TOWN OF BAY HARBOR ISLANDS
1175 MORRIS N. BROAD COMMUNITY CENTER
BAY HARBOR ISLANDS, FL 33154

DEVELOPMENT & REVIEW COMMITTEE MEETING AGENDA

Subject: Site Development Plan Application (2023 New Design) - 2nd Review
Casa Verde Condominiums – Multifamily Residential Complex (43 DU)
1130 – 1140 - 1150 93rd Street
Bay Harbor Islands Acct. No. SPR23-000019
MMPA Acct. No. 01-0702-1165

RESPONSE TO DRC COMMENTS

SCALE: 3/32" = 1'-0" DATE: MAY 25, 2023
SHEET NUMBER
A-108

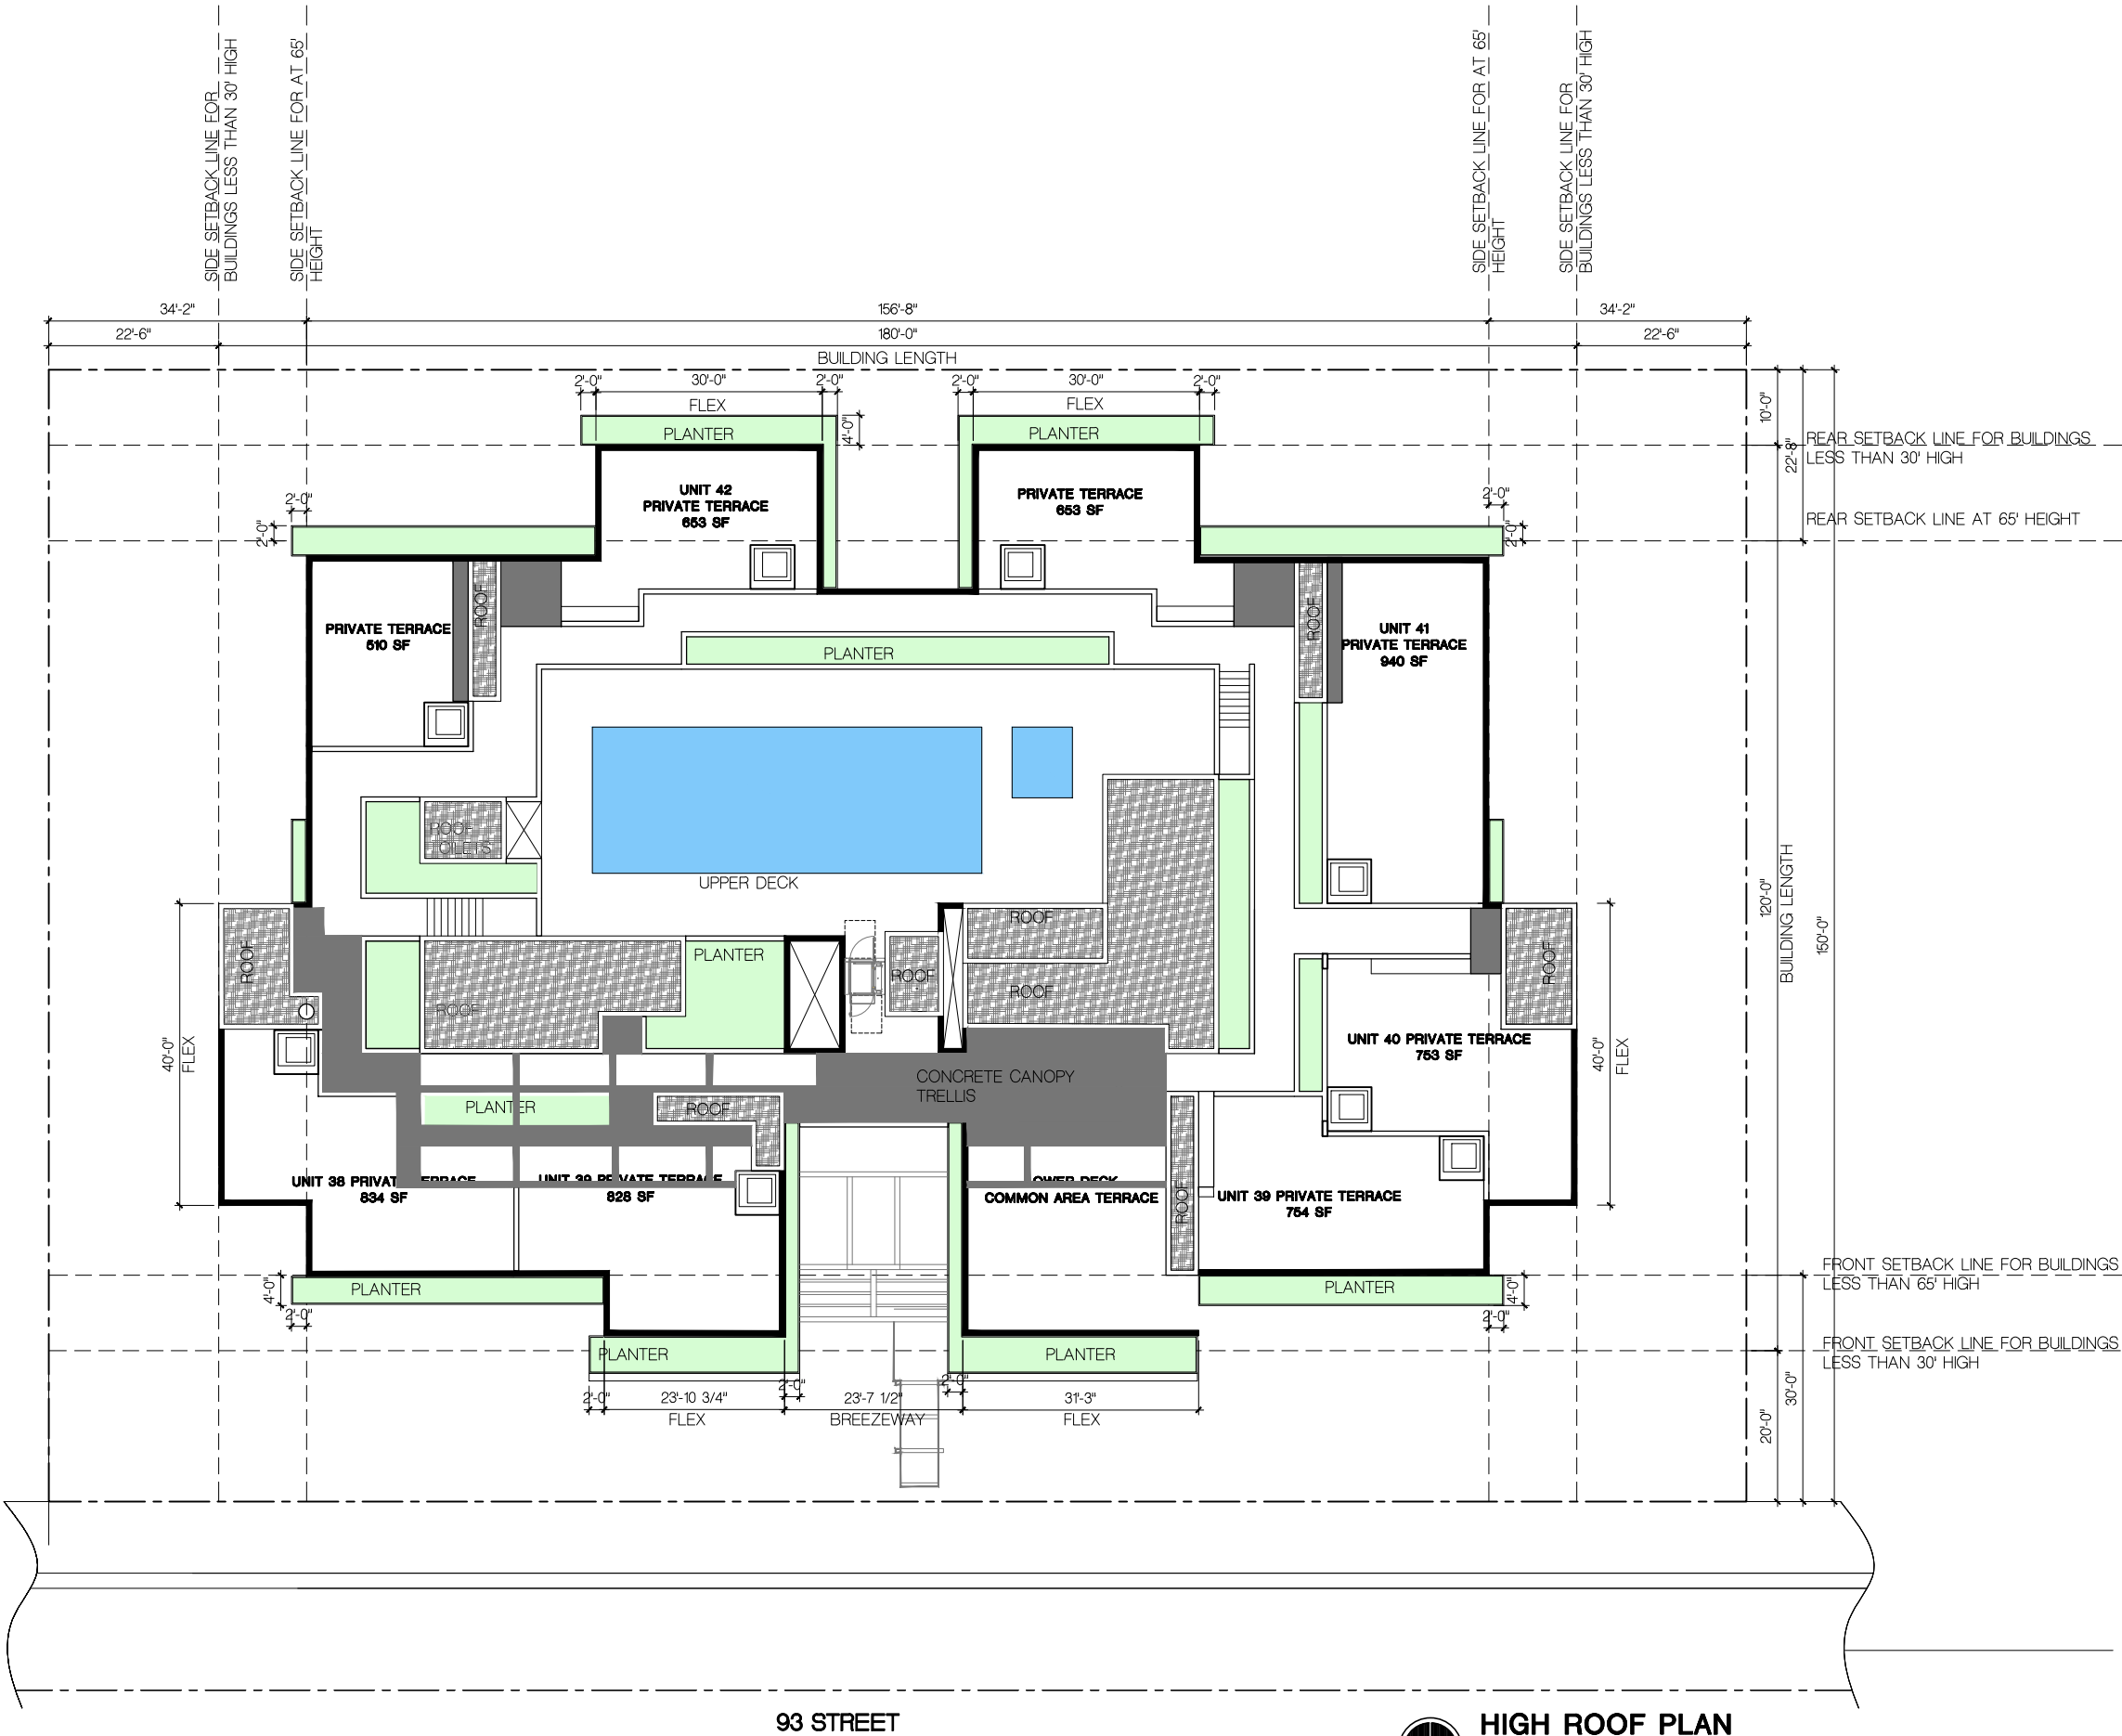
ON SHEET A-1.08 ROOFTOP PLAN A "RED LINED" AREA IS SHOWN SUPPOSEDLY ILLUSTRATING WHERE THE EDGE OF FLOOR 7 IS BELOW THE ROOFTOP. IF THIS WERE TRUE MOST OF THE ROOFTOP TERRACES WOULD NOT BE PERMITTED AS SHOWN. WE BELIEVE THE "RED LINE" AS DRAWN IS NOT SHOWN CORRECTLY – PLEASE VERIFY.

ON SHEET A-1.08 WHAT IS A “GENERATOR TOILETS AREA”? THERE ARE SEPARATE MEN’S/WOMEN’S BATHROOMS SHOWN TOO. PLEASE PROVIDE DETAILS.

We corrected Sheet A-1.08, the red line is now labeled "15' OFFSET FROM LINE OF BUILDING BELOW", and we added another red line that is labeled "LINE OF BUILDING BELOW".

Please refer to the revised Sheet A-1.08 where this area is simply labeled Generator

SHEET NUMBER
A-2.01

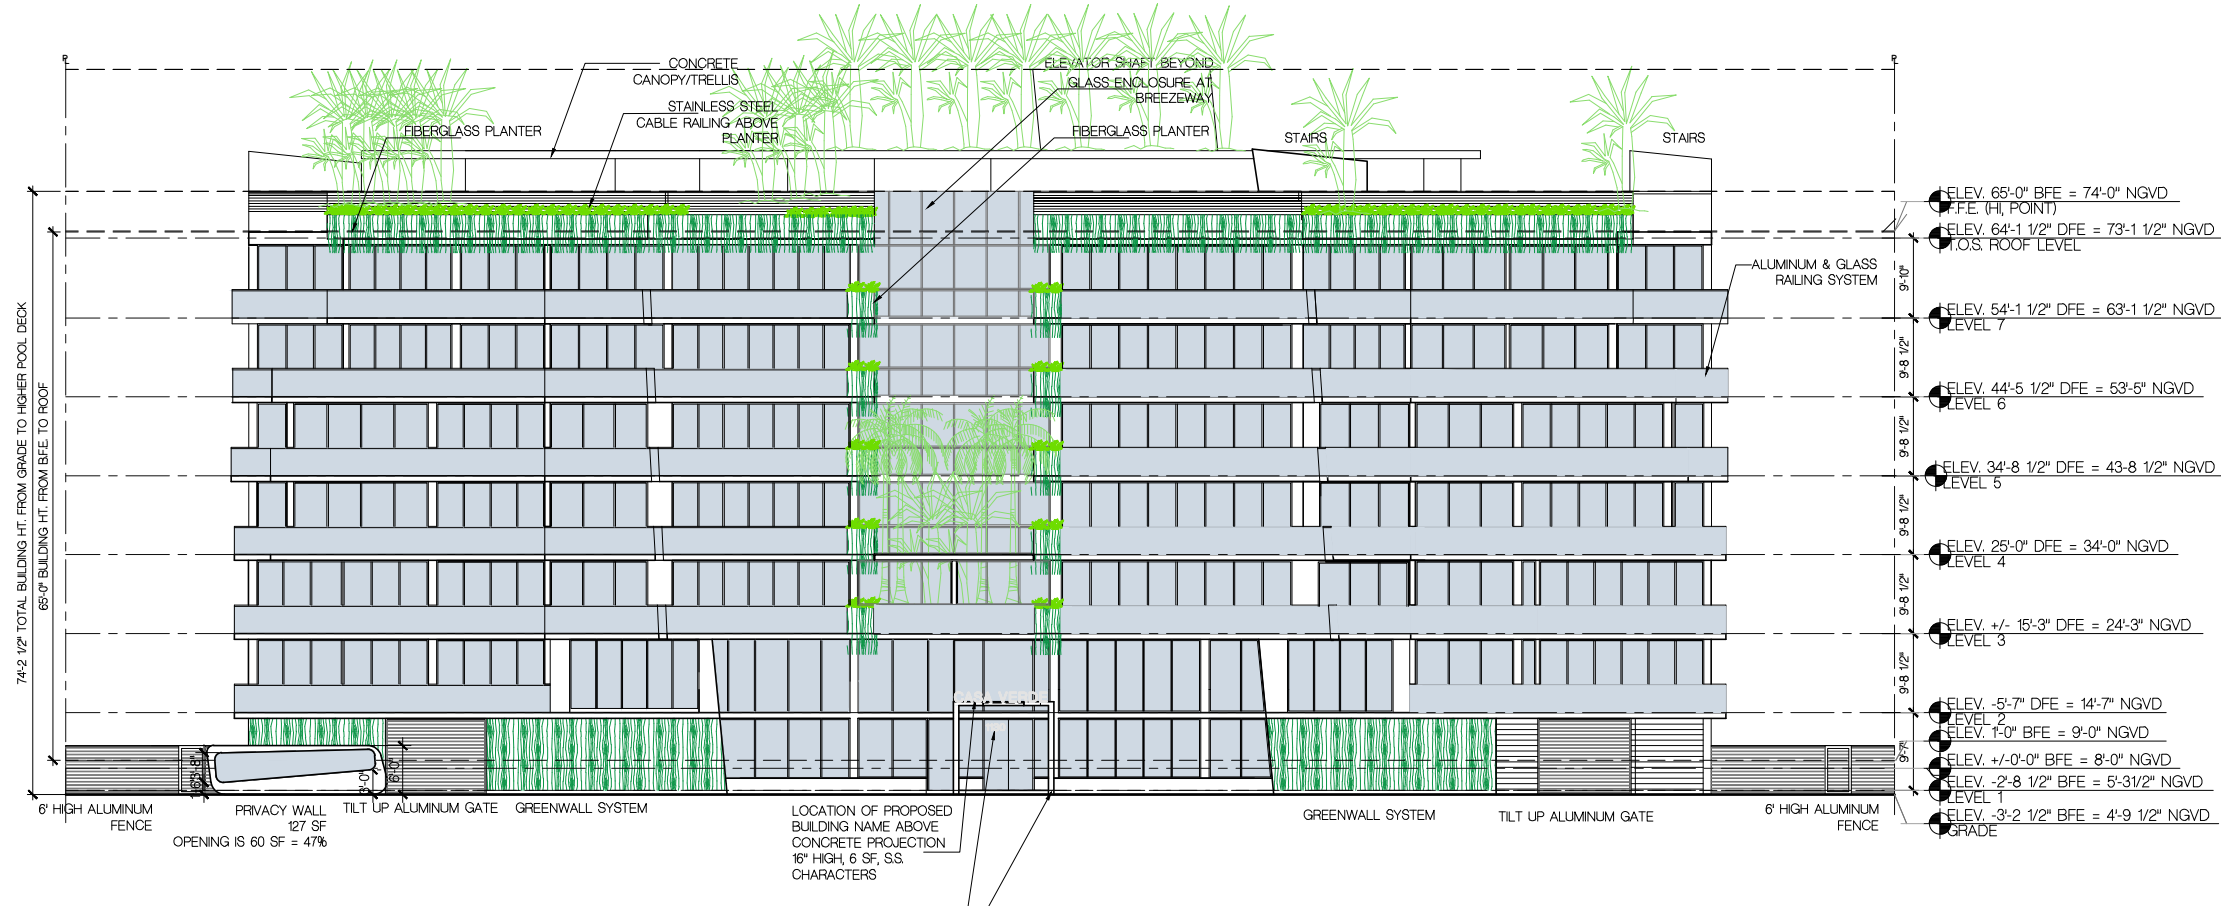
A DETAIL FOR THE PRIVACY WALL, AS WELL AS THE DUMPSTER ENCLOSURE, NEED TO BE INCLUDED IN THE PLANS.

Please refer to Sheet A-2.01 for the detail of the privacy wall. The Dumpster enclosure occurs within the building wall, shown on Elevations on Sheets A-2.01 & A-2.02.

PLANTING PLAN - GROUND LEVEL

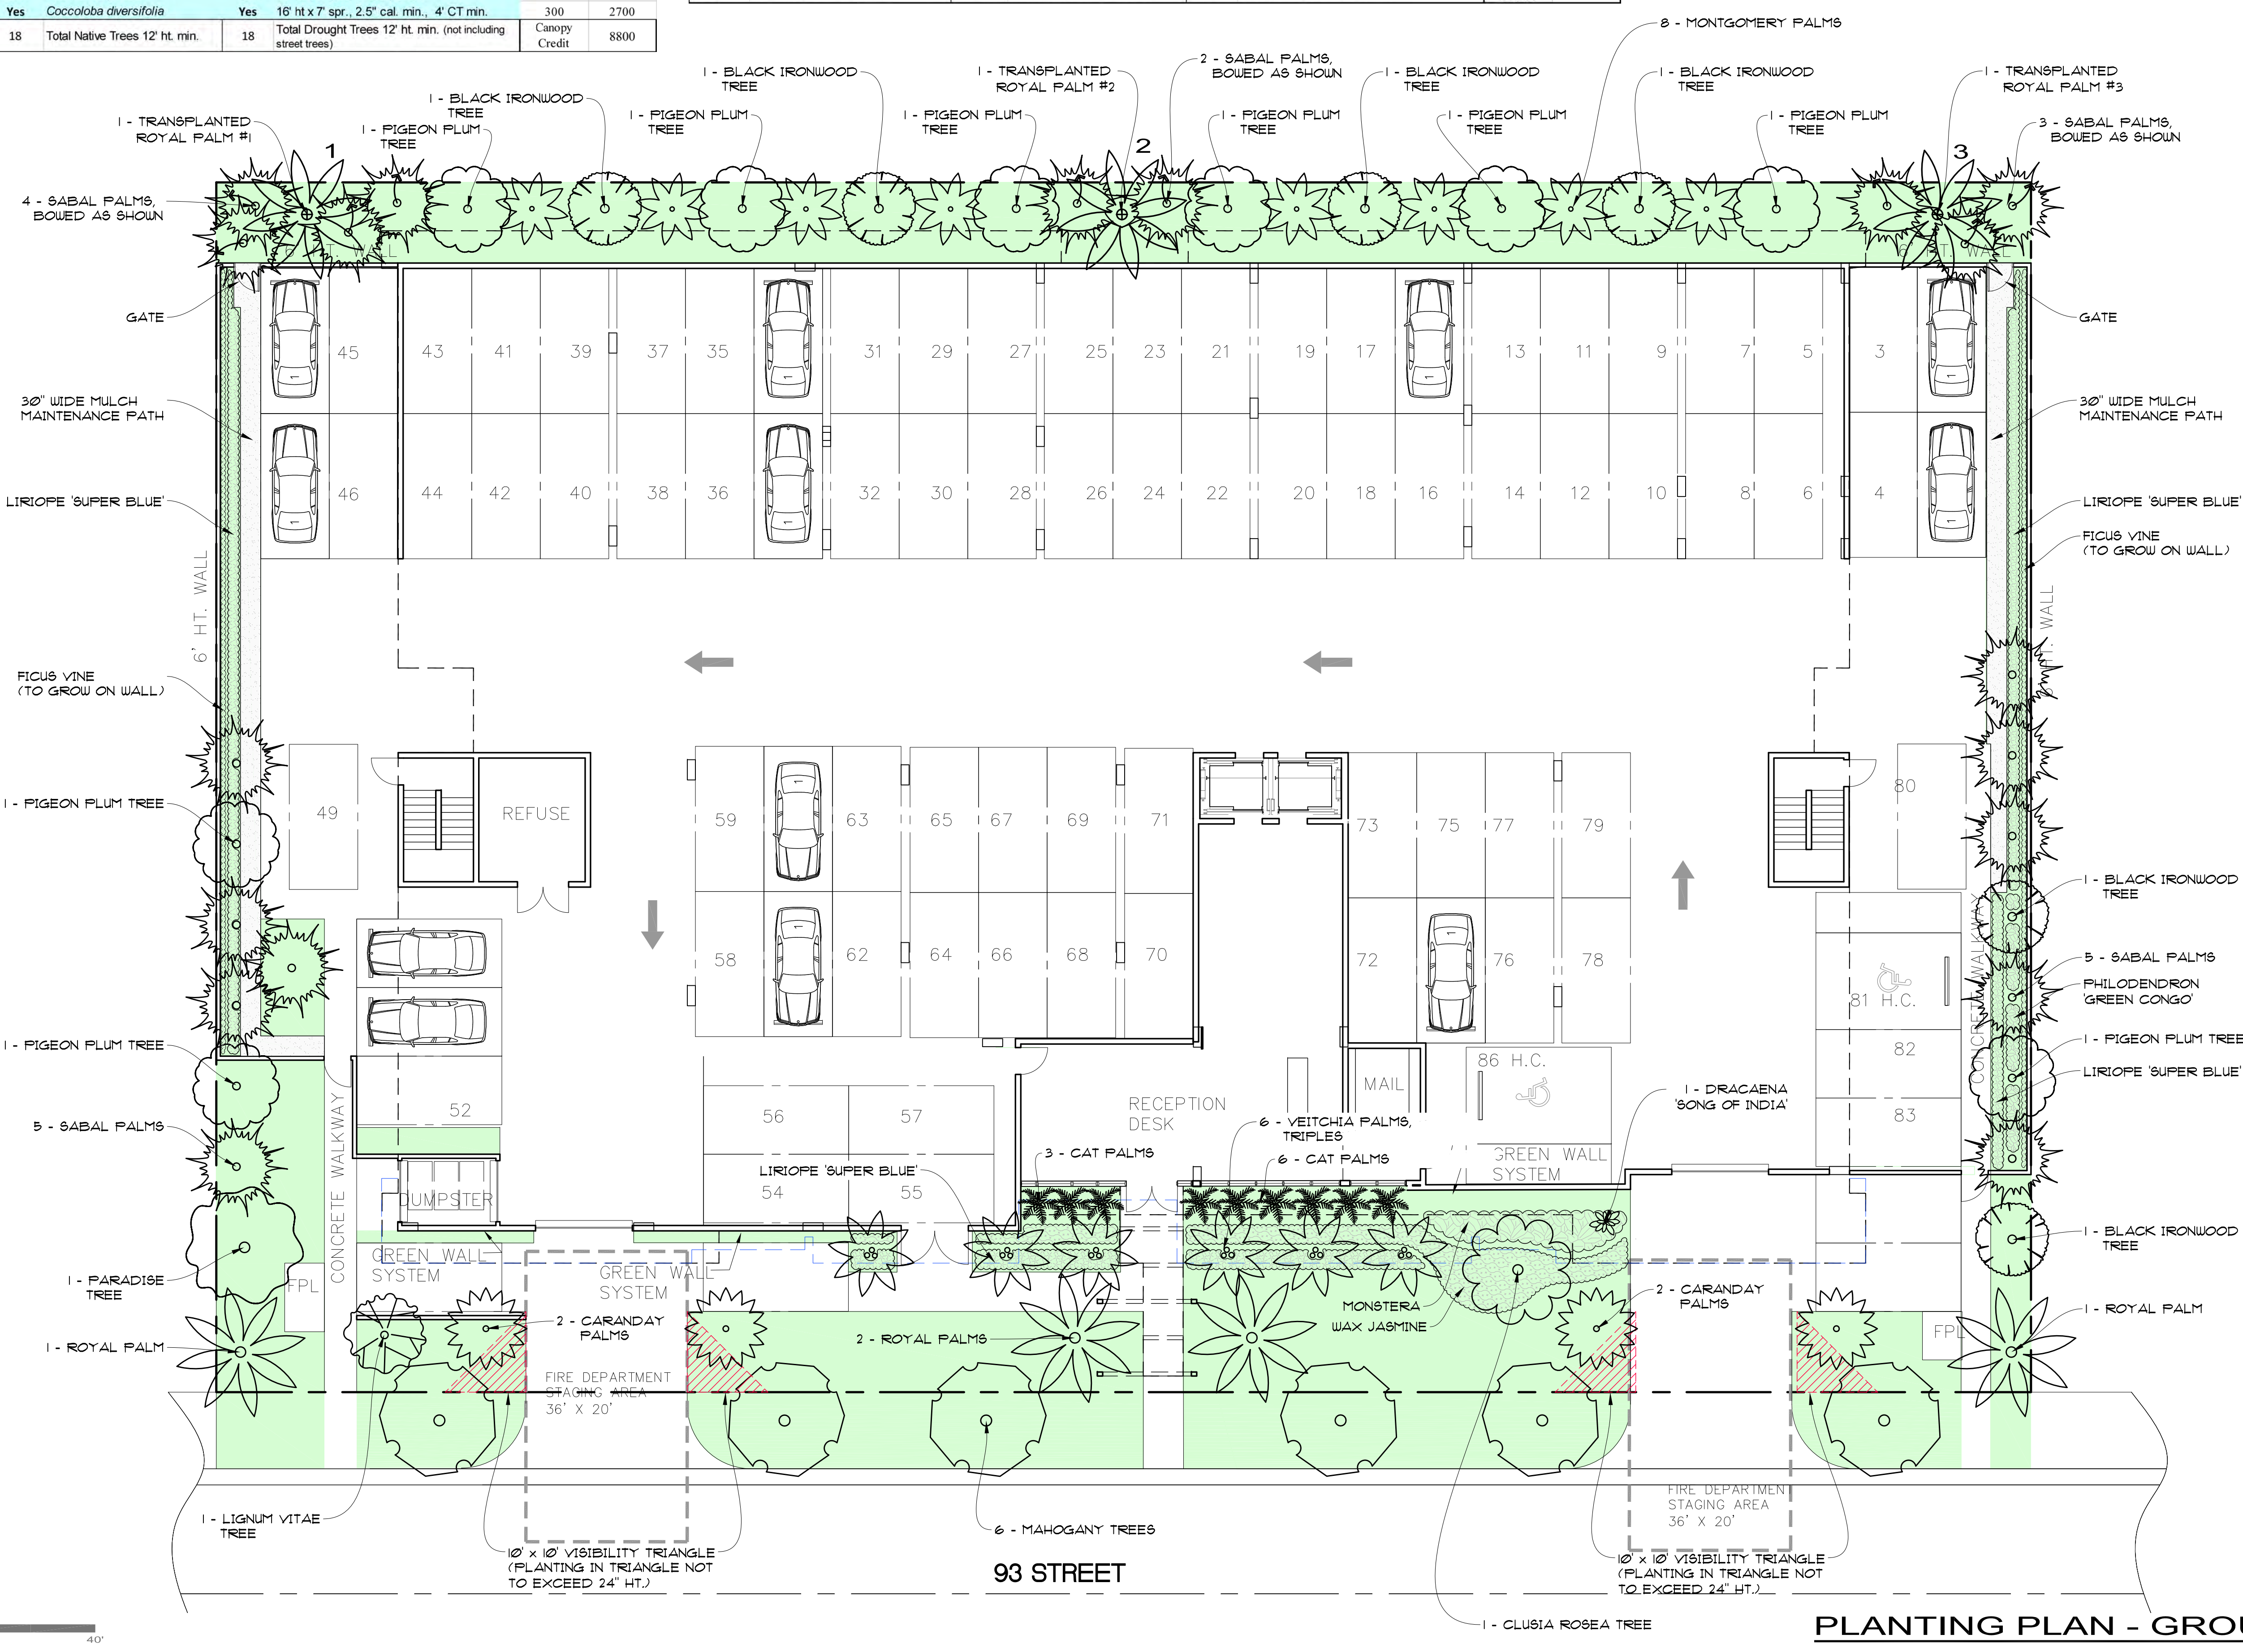
- 9) The Street Trees required by the Town for 93rd Street are “Gumbo Limbo” (15' x 6"). The project landscape plans show Mahogany trees. Please revise species.
